The Detroit Edison Company
One Energy Plaza, Detroit, MI 48226-1279

October 29, 2010
NRC3-10-0048

Subject: Detroit Edison Company Response to NRC Requests for Additional Information Letter Related to the Environmental Review

In References 2 and 3, the NRC requested additional information to support the review of Part 3 (Environmental Report) of the Fermi 3 Combined License Application (COLA). Since June 2009, Detroit Edison has submitted responses to all of the Requests for Additional Information (RAIs) identified in Reference 2 and 3 in a series of monthly letters (References 4 through 12). This letter is providing revised responses to eleven RAIs previously submitted in References 4 through 12. Detroit Edison is revising ten of these RAI responses as a result of telephone discussions with NRC staff. The remaining attached responses are discussed below.

Figure 4-4.1

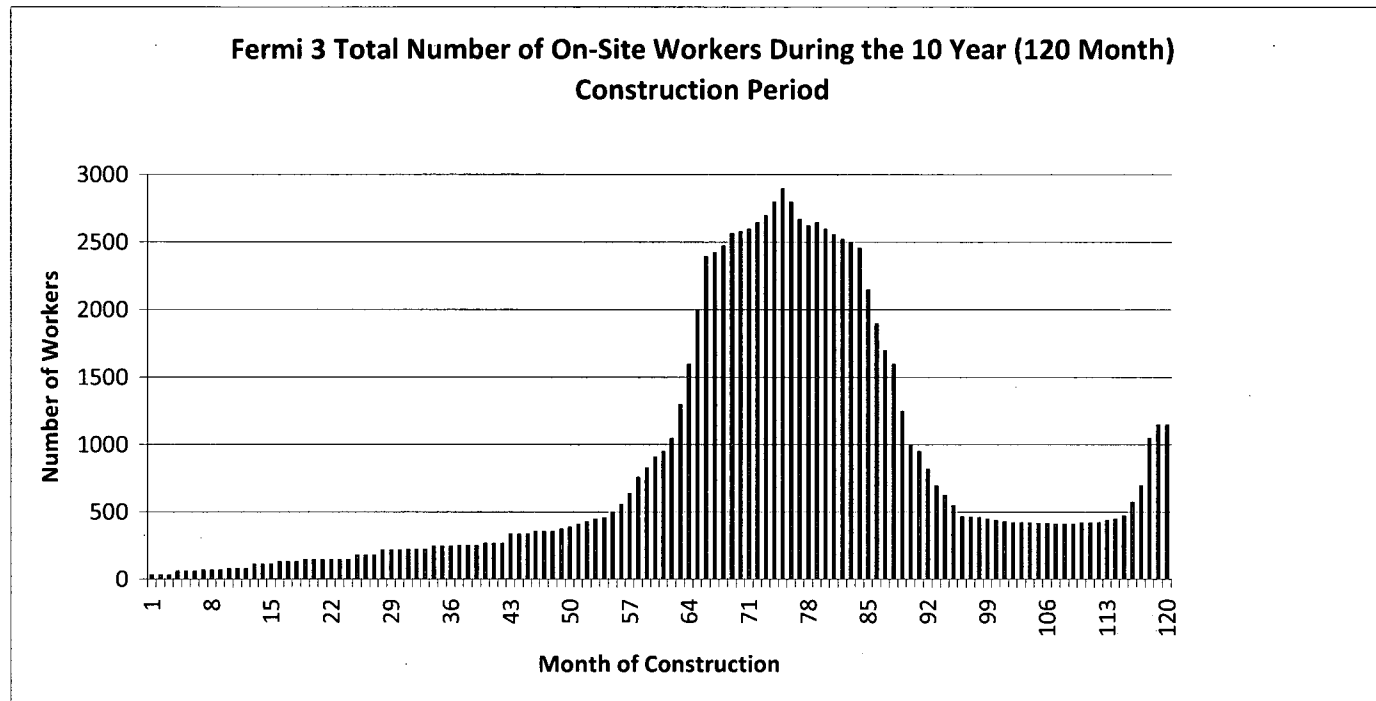
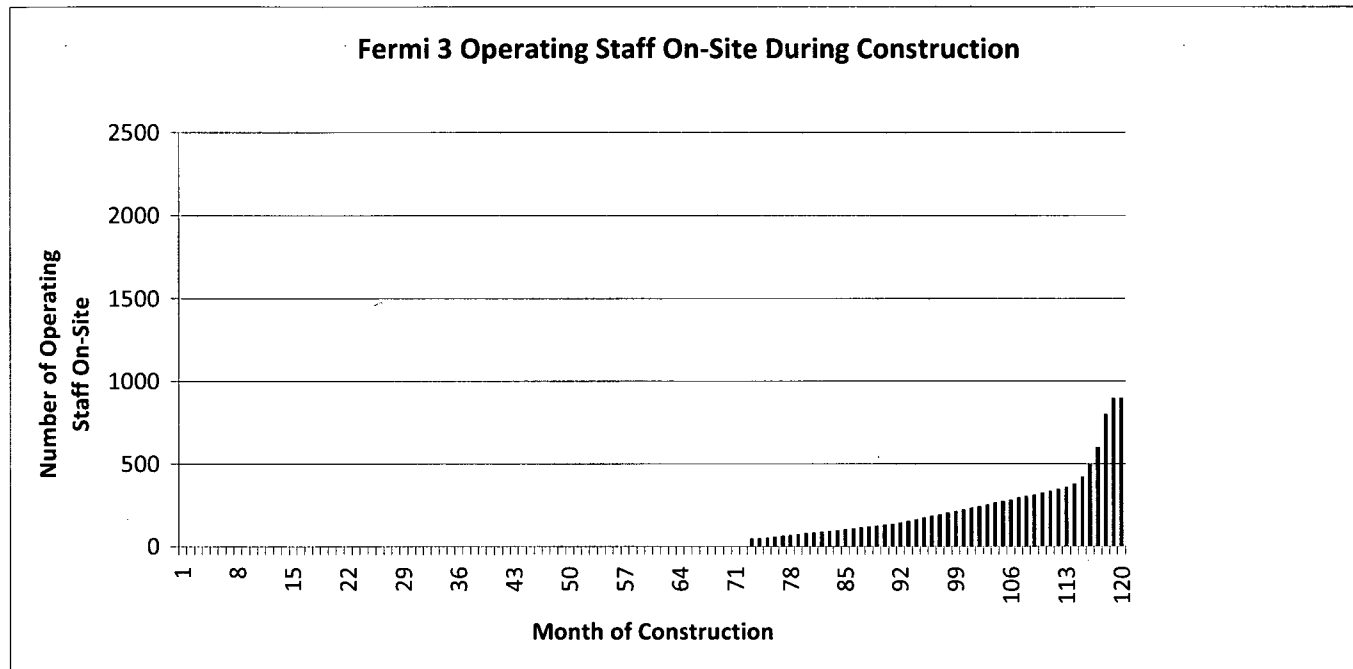
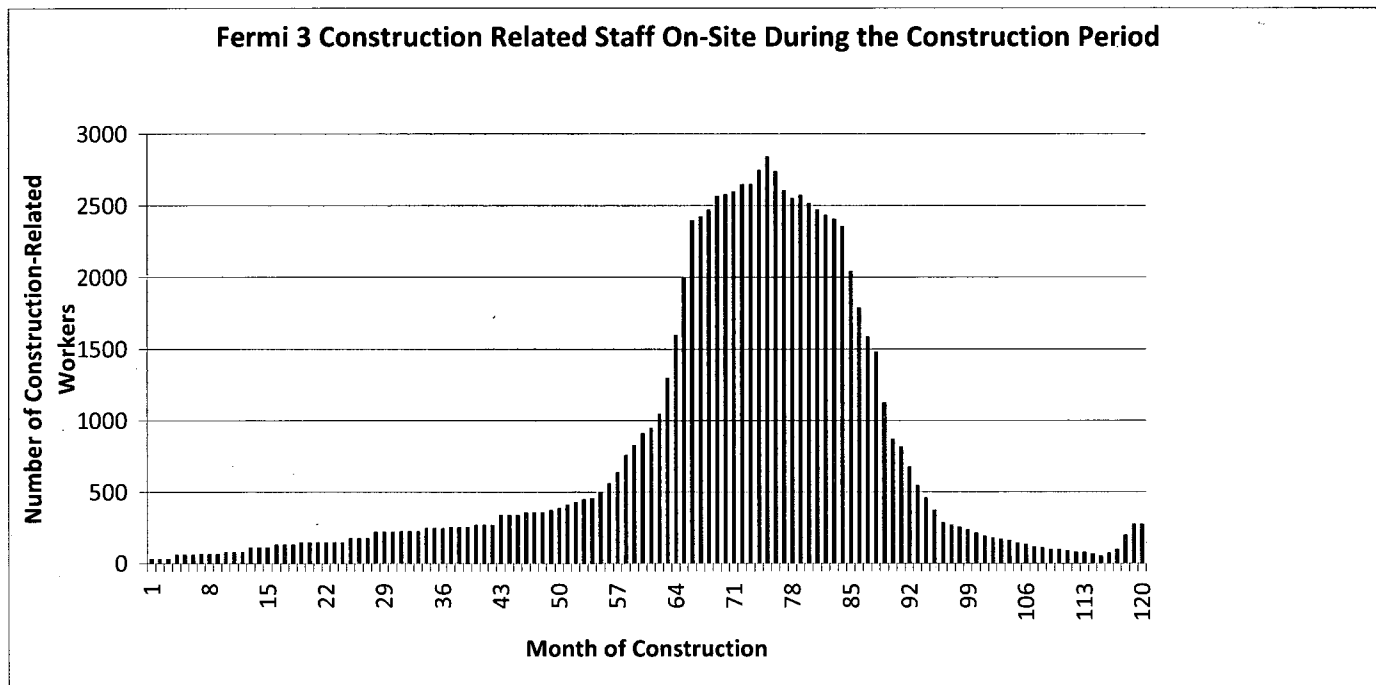
Provide information on the size and nature of the heavy construction industry and construction labor force within the region (size of labor force, unemployment rates, wages) specific to the job categories that would be used to support Fermi 3 construction (i.e., boilermakers, pipefitters, electricians, ironworkers, insulators, etc.).

Provide information on the job categories that would be recruited for the operations workforce, and the size of the labor force, unemployment rates, and wages for these laborers within the region.

It is assumed that the general monthly manpower loading pattern for all construction-related workers plus the Fermi 3 operations and maintenance staff will have the general shape shown in Figure 4.4-1. Figure 4.4-2 and Figure 4.4-3 further break down this total manpower requirement into the month-by-month Fermi 3 operations and maintenance staff, and the construction-related manpower requirements less the Fermi 3 O&M staff. All three figures show the loading over the 120 month (10-year) Phase 1 plus Phase 2 total construction length.

Figure 4. Previously Recorded Submerged Cultural Resources Locations

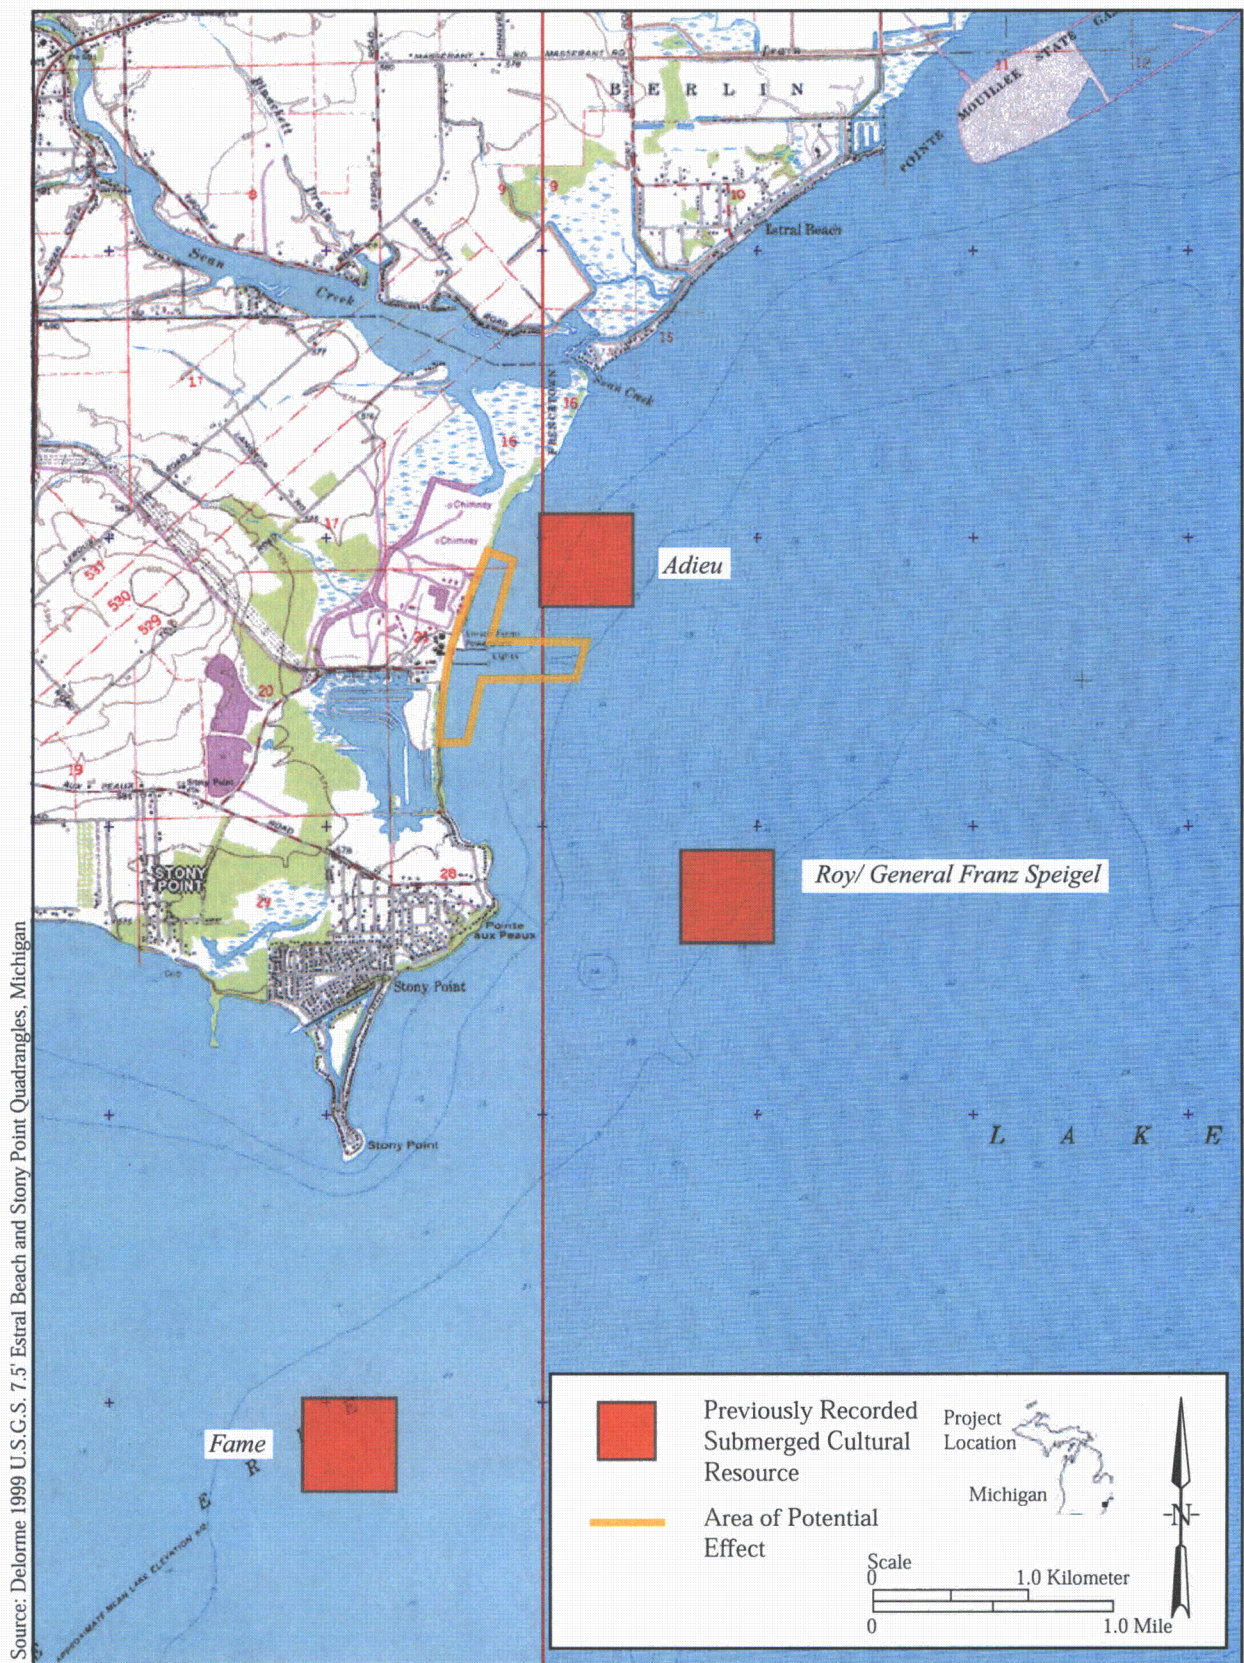
An error was identified on Figure 4 of the study, which depicts the location of several shipwrecks on Lake Erie in the vicinity of the Fermi site. The shipwrecks are in the correct location, however, the names were incorrect. Additionally, a clarifying statement was added to the final paragraph of the report stating that any potentially significant maritime resources that may be present within the project area may exhibit degraded integrity, due to the dynamic and turbulent nature of the shallow-water near-shore environment.
